NRL Report No. R-2093  
BuShips Prob. X71S

TESTS OF THE MODEL SF RADAR

Contractor - The Submarine Signal Co.

NAVAL RESEARCH LABORATORY  
ANACOSTIA STATION  
WASHINGTON, D. C.

VIDEO RESPONSE CHARACTERISTIC  
 MODEL SF RADAR RECEIVER MADE BY  
 SUBMARINE SIGNAL COMPANY,  
 BOSTON, MASS.

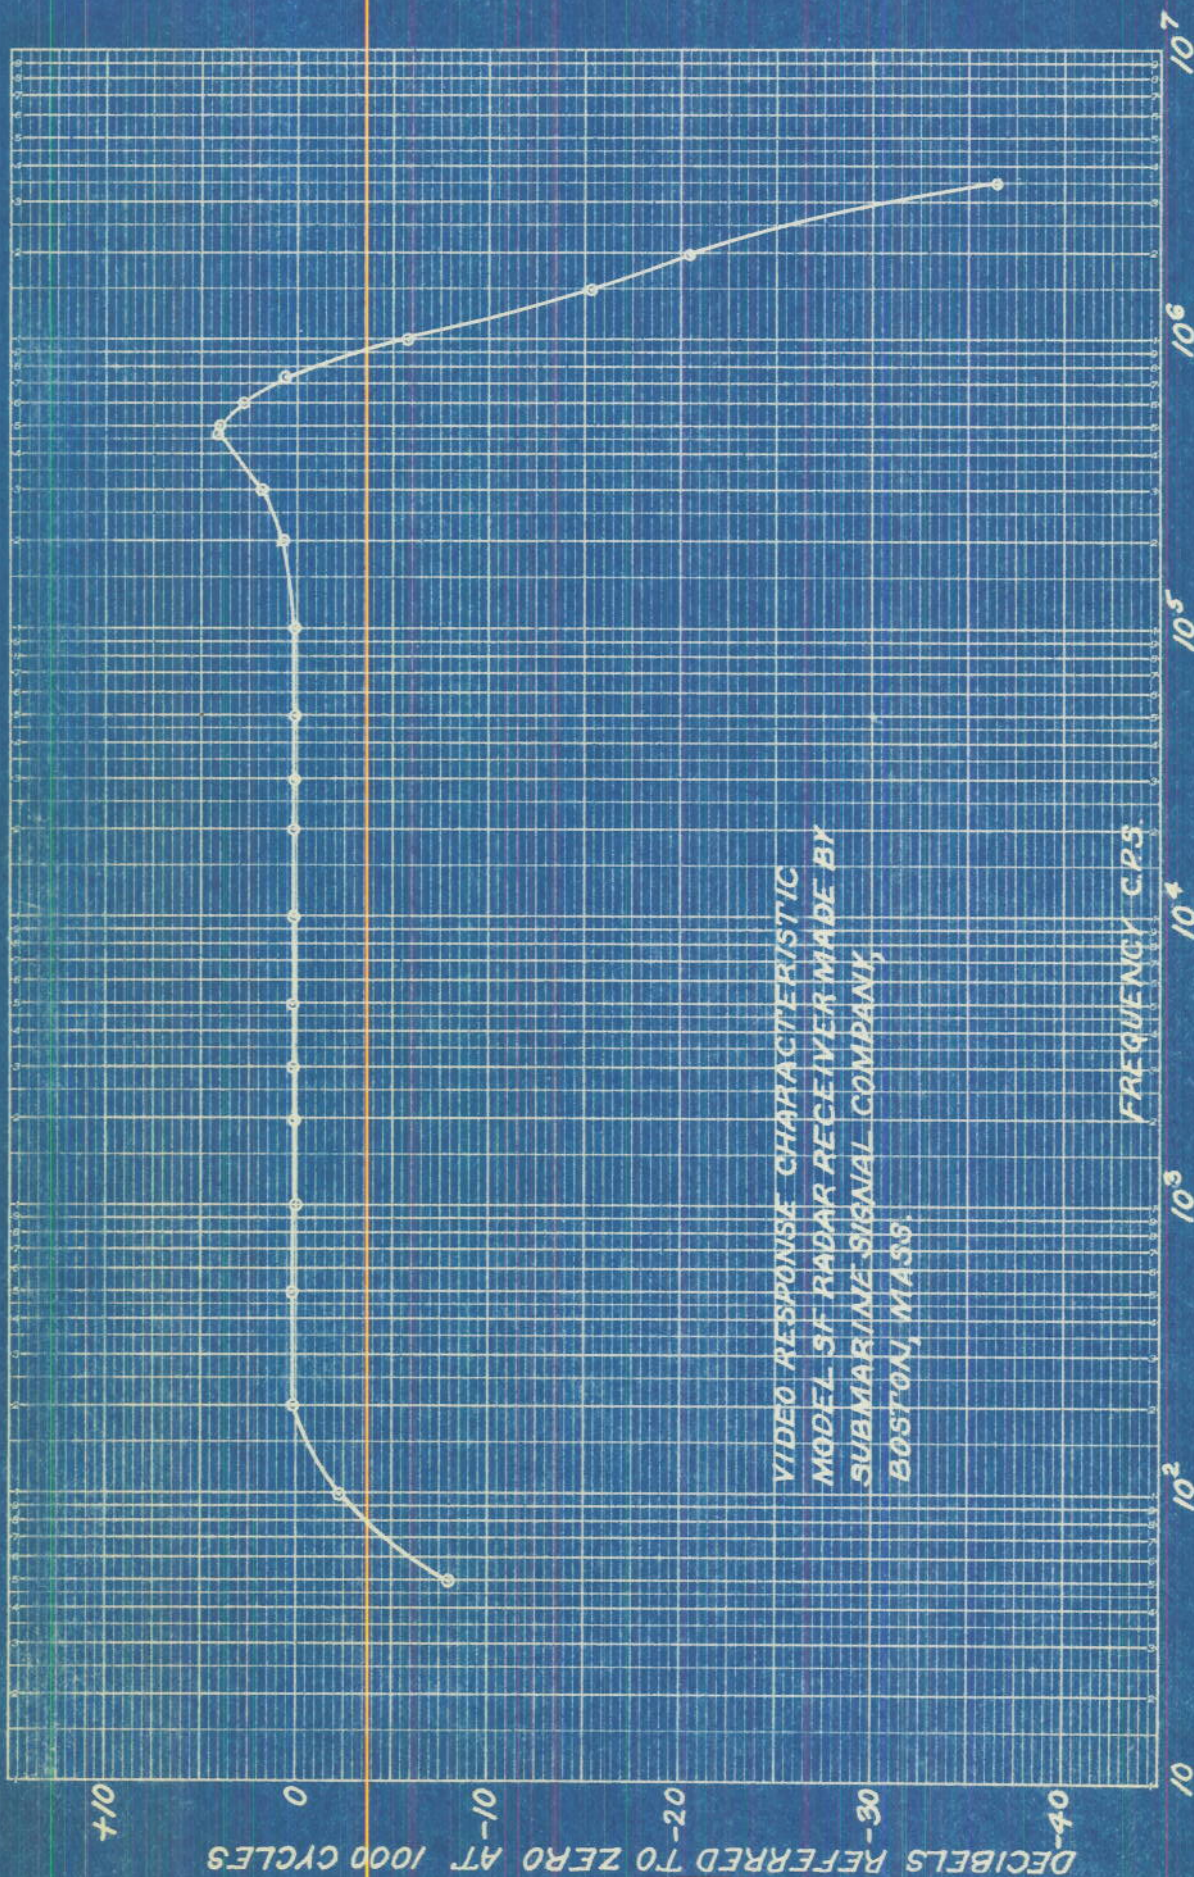
- 3-21-1. The video response, referred to zero at 1000 cycles, is essentially flat from 200 cycles to 200 kilocycles. A slight peak occurs at 470 kilocycles where the response rises to +4.1 decibels. At one megacycle the output is down -5.8 decibels and is -36.5 decibels at 2.5 megacycles. Graphical results are shown on plate 3.

PLATE 103

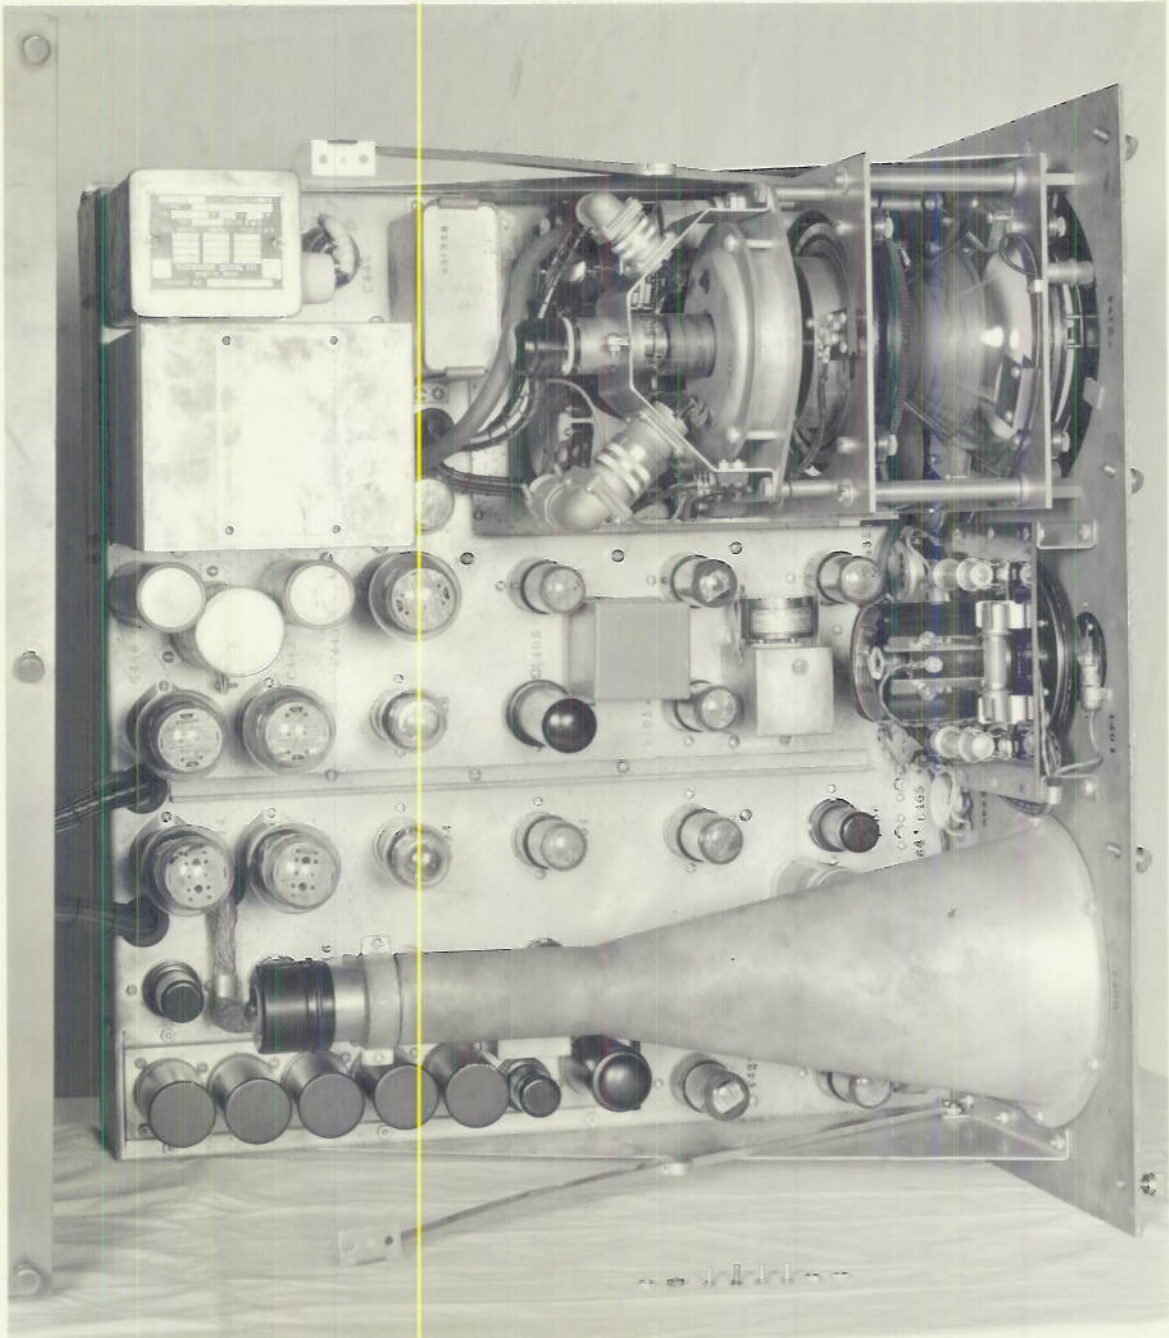
The construction of the frame, cabinet and chassis of the receiver-indicator is sturdy. However, the chassis locks of the present equipment will not permit the removal of the chassis by more than four inches. It is necessary to remove a vacuum tube and to spring aside one of the locking arms before the chassis can be pulled out. In this position it is extended three quarters of its total length. However, the i-f sub-chassis and a number of components remain inaccessible. See plate 103.

PLATE 105

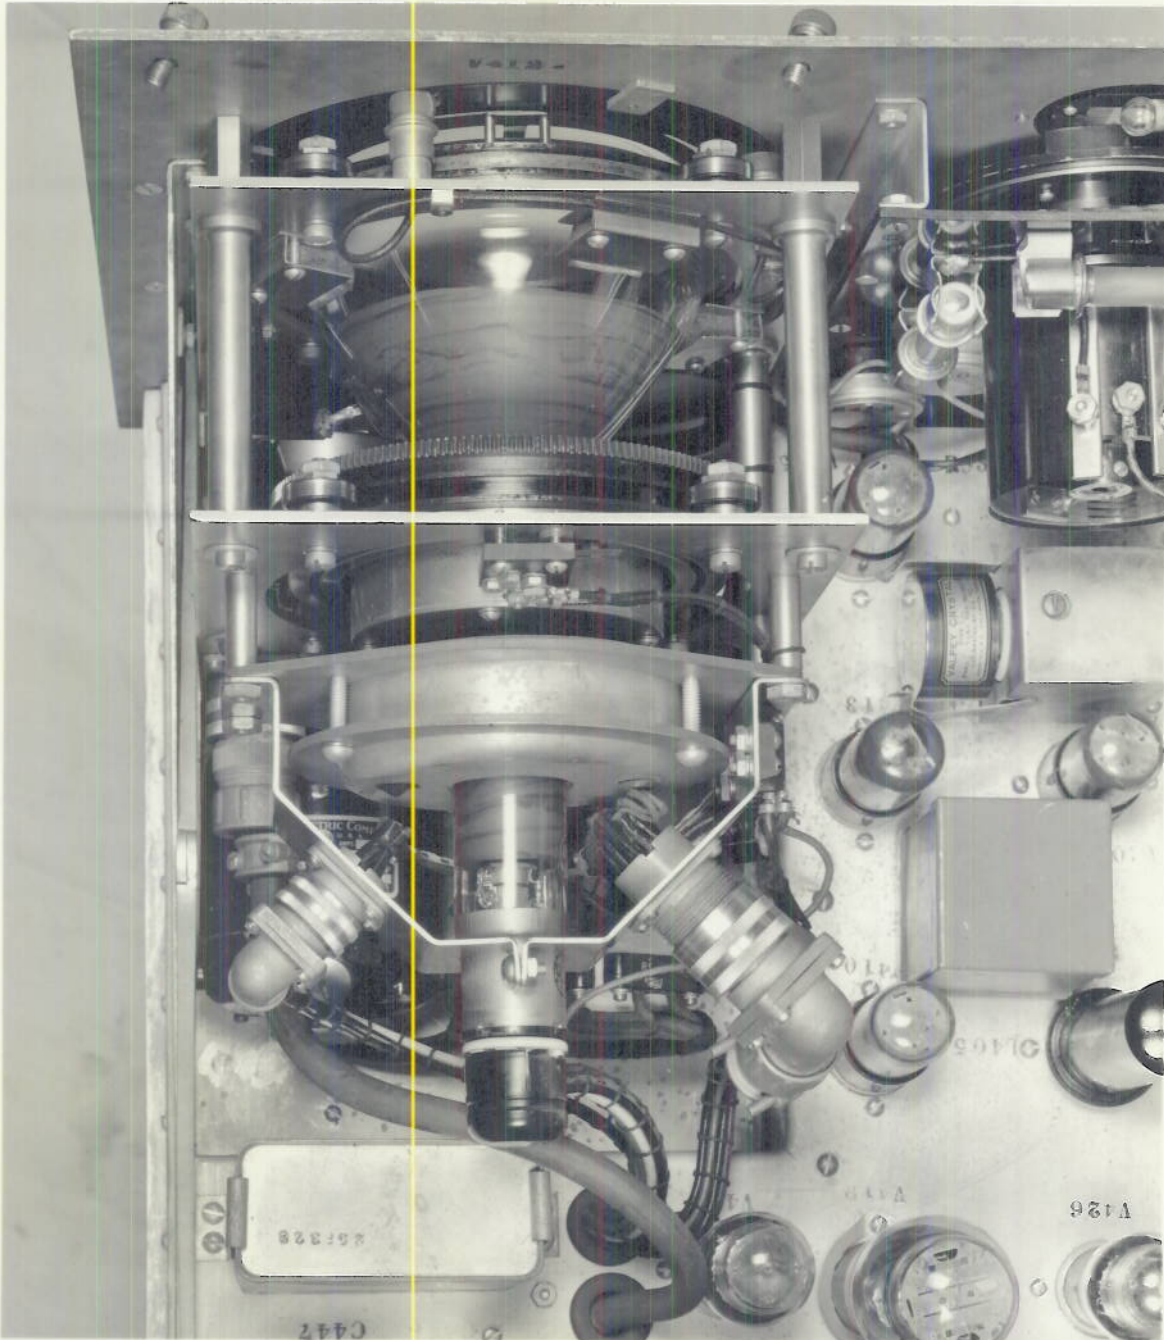
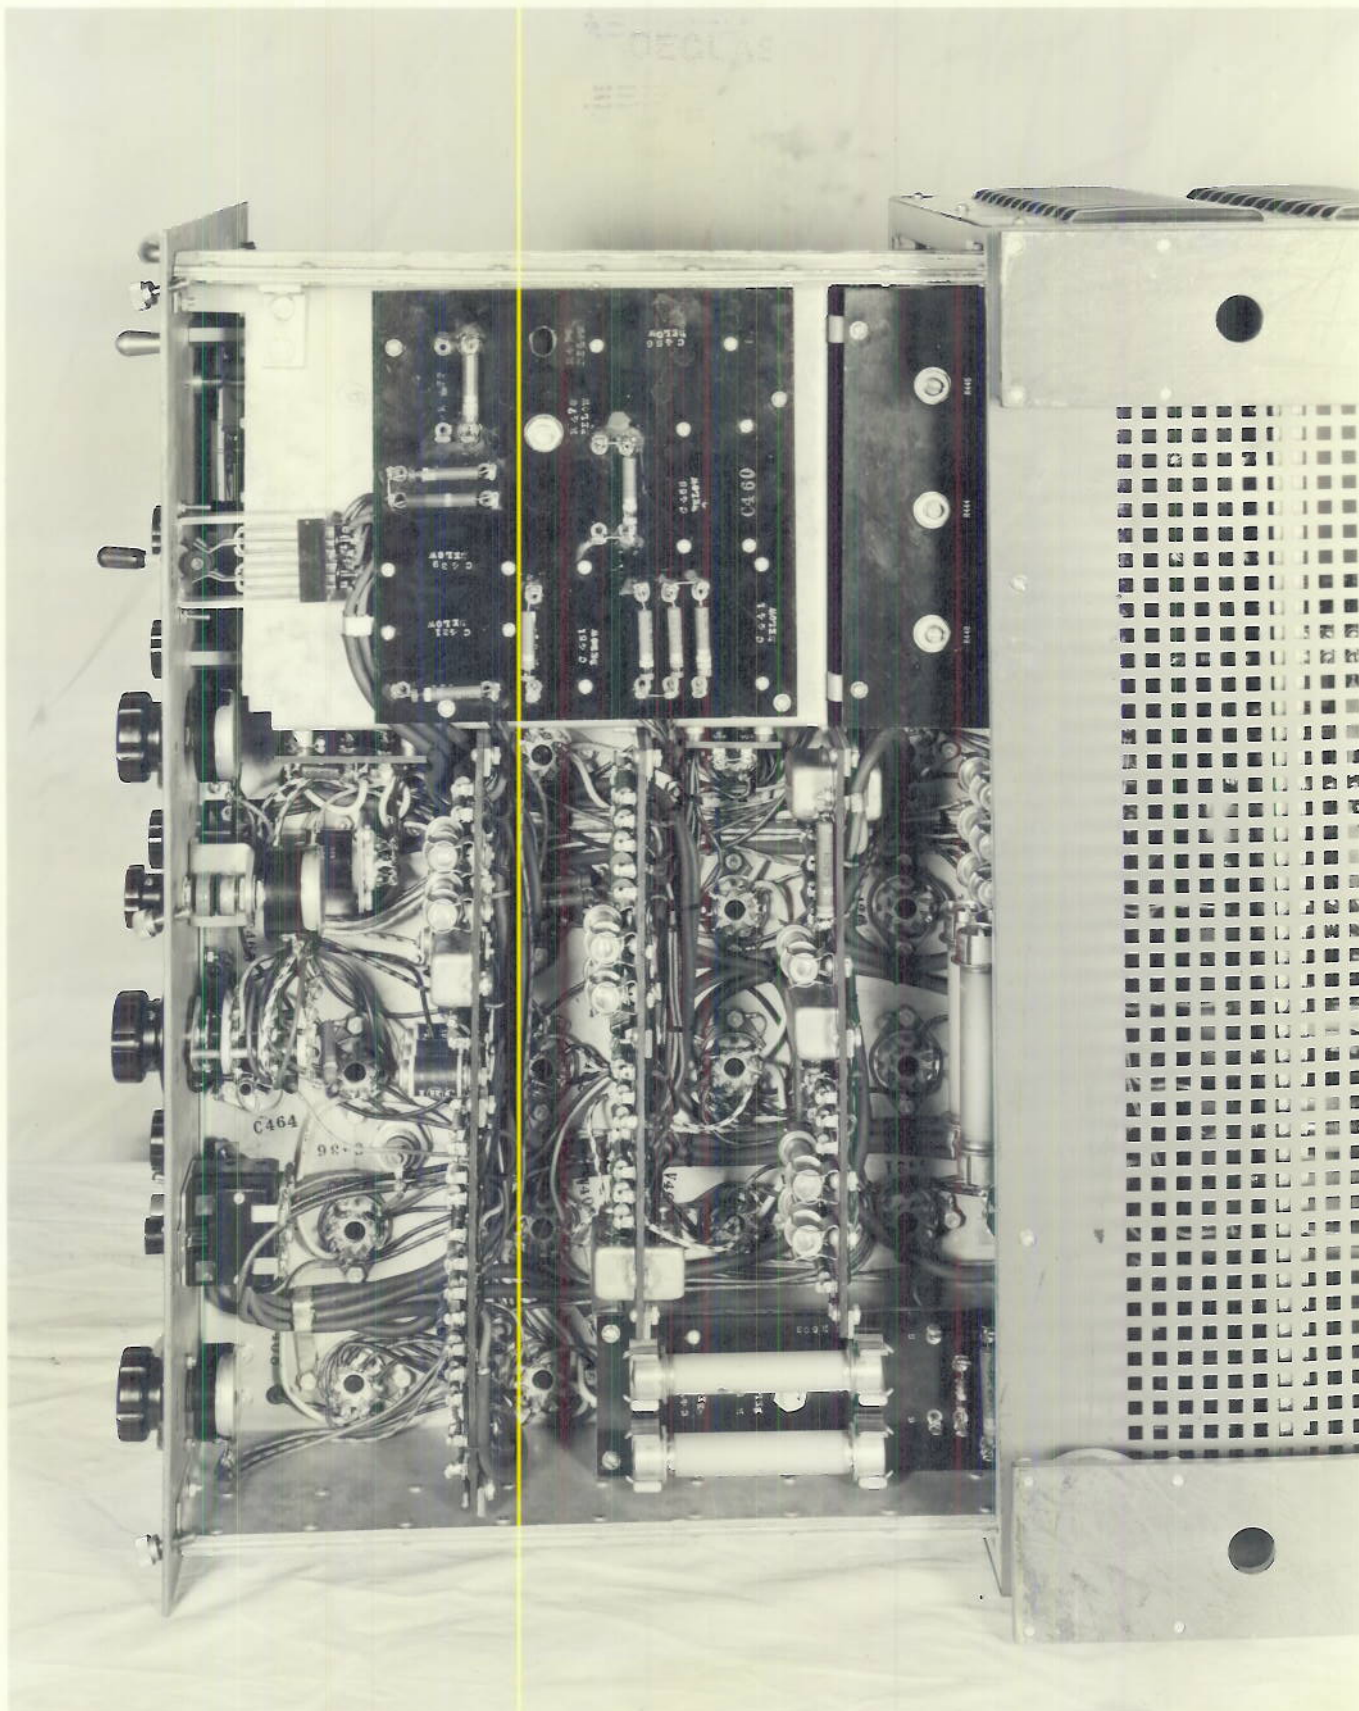
- 3-9-9. It would be desirable to change the mechanical design of the clamp that secures the base of the PPI tube so as to allow the replacement of this tube by loosening one screw rather than the four which is now necessary. See plates 104 and 105.
